**ADDENDUM
CITY OF AUSTIN, TEXAS**

Solicitation: IFB SMB0201

Addendum No: 2

Date of Addendum: 05/27/2016

EXHIBIT 1 – SITE LAYOUT MAP

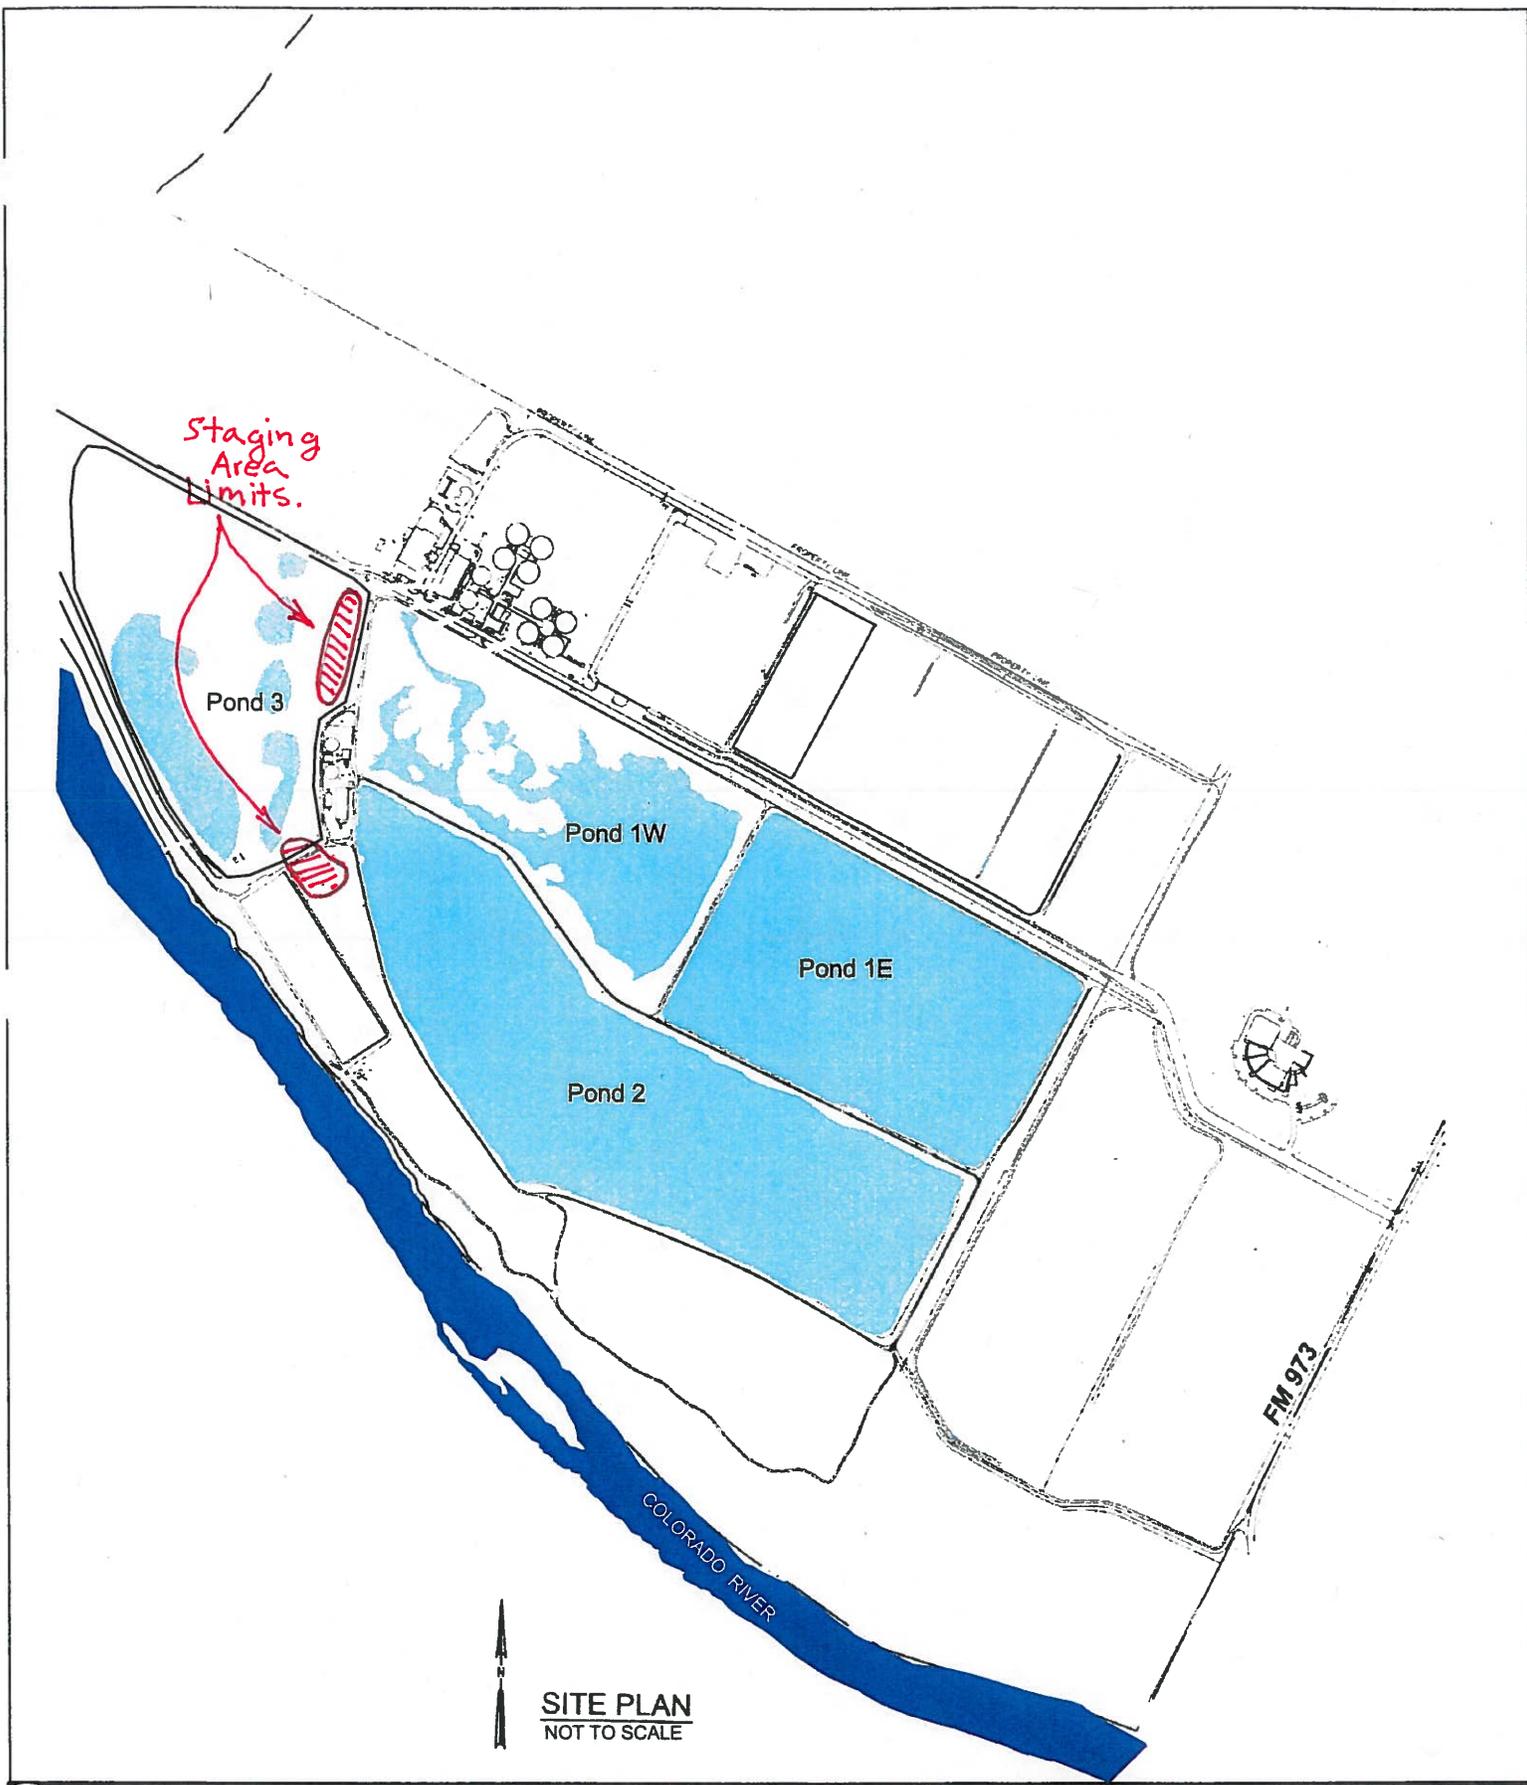
5. Question: What permits must the Contractor obtain for the project?
Answer: None. It is the City's responsibility to obtain all required permits.
6. Question: Is there an area on site (HBBMP property) where tree debris may be stored temporarily?

Answer: Yes, though the Austin Water Utility takes no responsibility or liability for those materials. See map provided with Addendum.
8. Question: Is there an area on site (HBBMP property) where equipment may be stored?

Answer: Yes, though the debris must be cleared/removed on a not to exceed bi-weekly basis. See map provided with Addendum.
7. Question: Is there an area on site (HBBMP property) where materials may be stored for re-compaction?

Answer: Yes, though the Austin Water Utility takes no responsibility or liability for the equipment. See map provided with Addendum.
9. Question: Specification 604S requires weed management. Does the City expect the management of weeds given the number of non-native species of grasses and plants in the immediate area?

1. Site staging area map is attached.
2. The attendance roster from the Pre-Bid Conference on May 25, 2016, is attached.
